**CULTURAL RESOURCES OFFICE  
PRESERVATION BOARD  
REGULAR MEETING  
MONDAY – JUNE 27, 2016 — 4:00 P.M.  
1520 MARKET ST. #2000, ST. LOUIS, MO. 63103  
[www.stlouis-mo.gov/cultural-resources](http://www.stlouis-mo.gov/cultural-resources)**

DATE: June 27, 2016  
 ADDRESS: 6001-07 Pershing Avenue  
 ITEM: Preliminary Review: Construction of three single-family houses  
 JURISDICTION: Skinker-DeBaliviere Certified Local Historic District — Ward 28  
 STAFF: Bob Bettis, Cultural Resources Office

DATE: June 27, 2016  
ADDRESS: 4176 Blaine Avenue  
ITEM: New construction: construct one two-story, single-family house.  
JURISDICTION: North I-44 Certified Local Historic District — Ward 19  
STAFF: Bob Bettis, Cultural Resources Office

DATE: June 27, 2016  
ADDRESS: 4531 McPherson Avenue  
ITEM: Appeal of the Director's denial to retain retaining walls constructed without a permit.  
JURISDICTION: Central West End Local Historic District — Ward 28  
STAFF: Andrea Gagen, Preservation Planner, Cultural Resources Office

**STREETSCAPE**

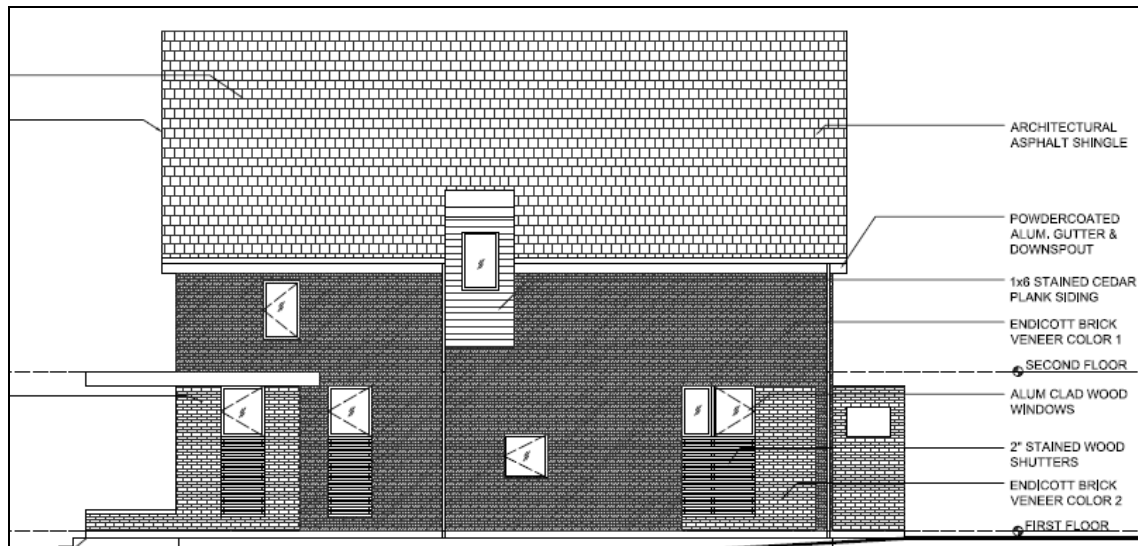
**Complies. There are a variety of building heights on this block, but the proposed buildings appear to meet this requirement.**

**Complies. The proposed setbacks are in line with the adjacent buildings.**

**Complies. Proposed building floor heights, window proportions, scale and materials are compatible with the adjacent buildings.**

**Complies. There are a number of different roof types on the block. The selected gabled roofs are compatible with the surrounding structures.**

**SITE PLAN**

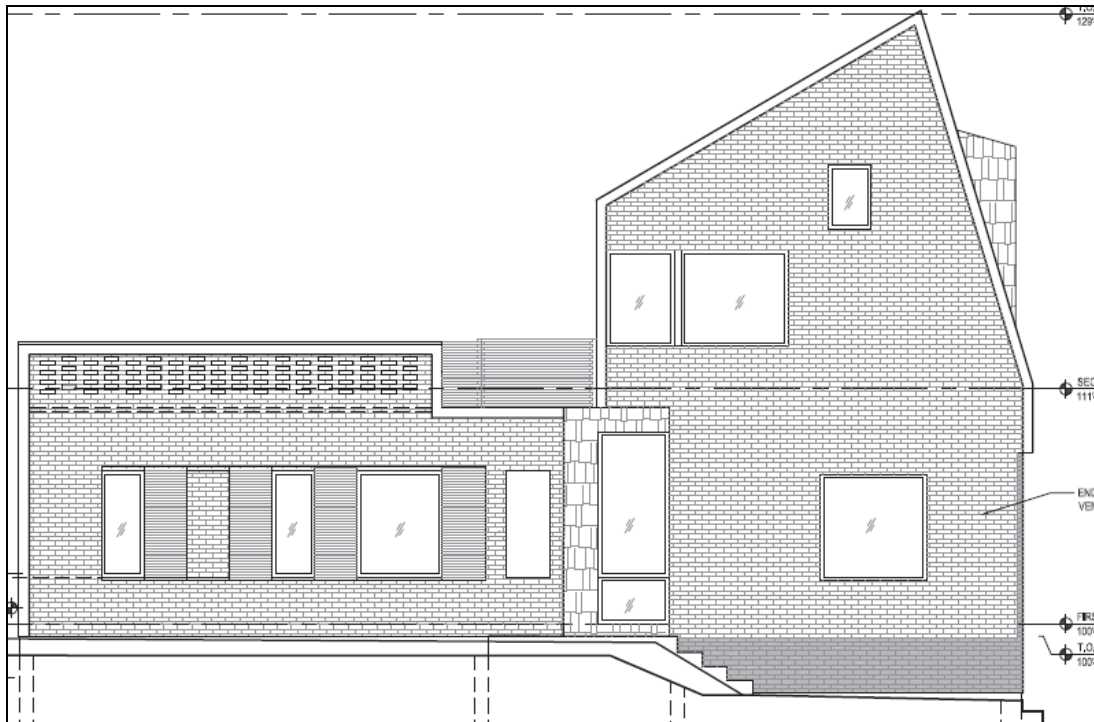
**Partly complies: The front façade will be clad in brick with the exception of a large spandrel panel above each double window. These will be of cement board, a material that is not found on this block.**

**Mostly complies. The building's details are contemporary and spare. While historic precedent appears in front openings arranged in bays, and a clear differentiation between foundation and upper wall, the building lacks other traditional elements of the district's historic buildings such as a defined cornice line.**

**Partly complies. While window openings are generally close to historic proportions, the presence of casement and fixed-sash windows, set in pairs without mullions and the proportions of the second-story window above the entry are not reflective of historic details.**

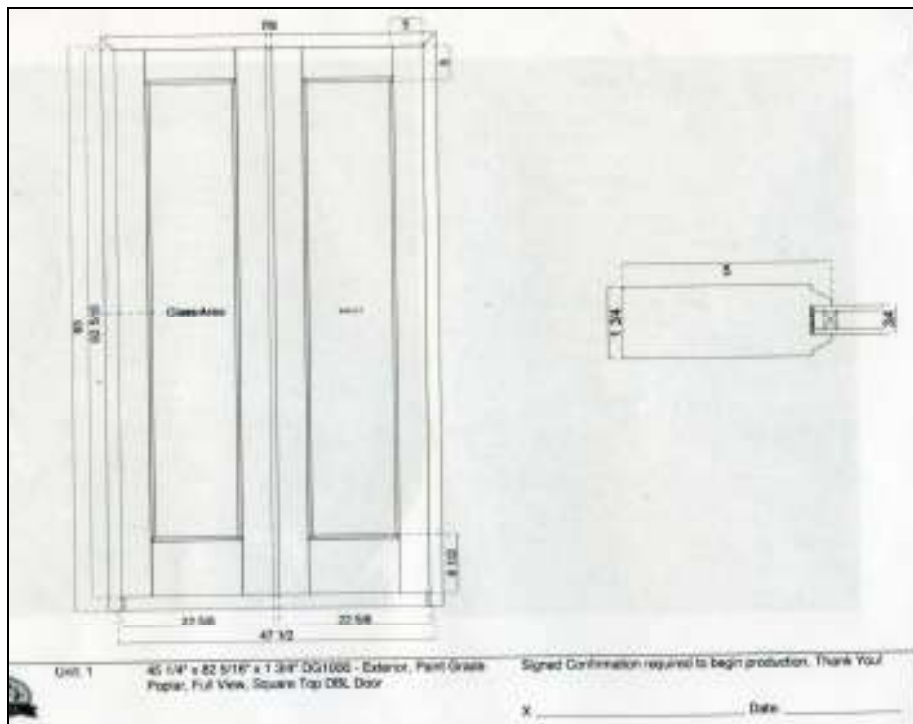
**Does not comply. The owner proposes to remove a triple-hung window and replace it with paired French doors. The existing window is considered a Special Window under the Standards and cannot be altered.**

**Does not comply. The installed wall is an artificial material that does not replicate any material dominant within the historic district.**

**Does not comply. The original terrace has been altered by the introduction of a new artificial stone block retaining wall.**

**ORIGINAL DESIGN**

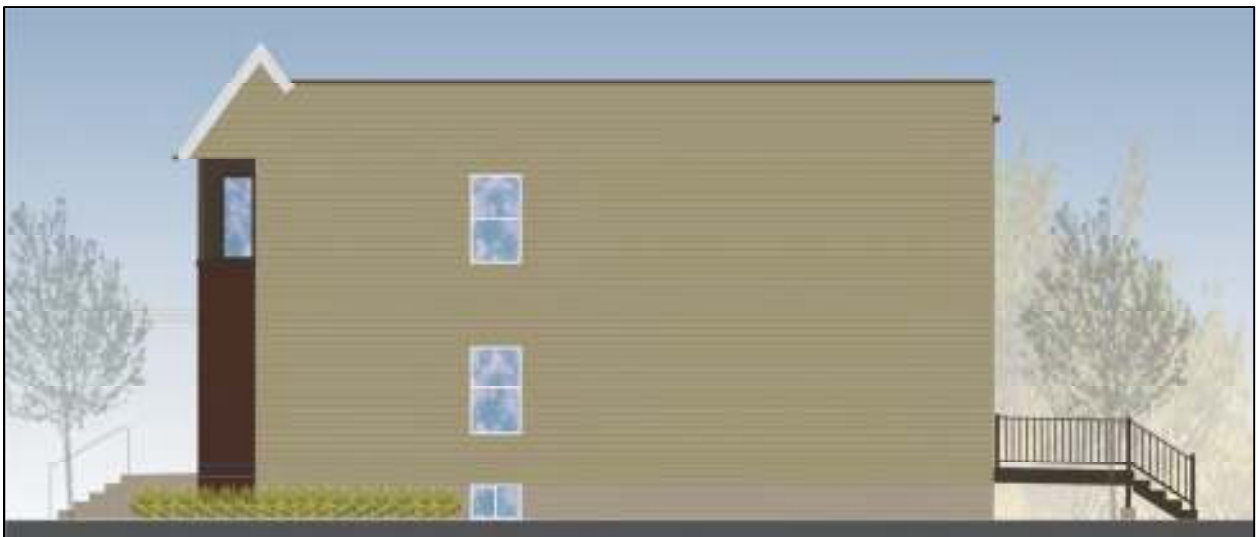
**Partly complies. The original design presented a fenestration pattern with openings vertical in proportion and arrayed in bays, that considerably enhanced its compatibility with the historic fabric of the district. The current design has introduced large fixed-light windows at the second story, which are no longer placed symmetrically over the openings of the first story. However, as the façade is uniform in color, the effect of this change is relatively subtle.**
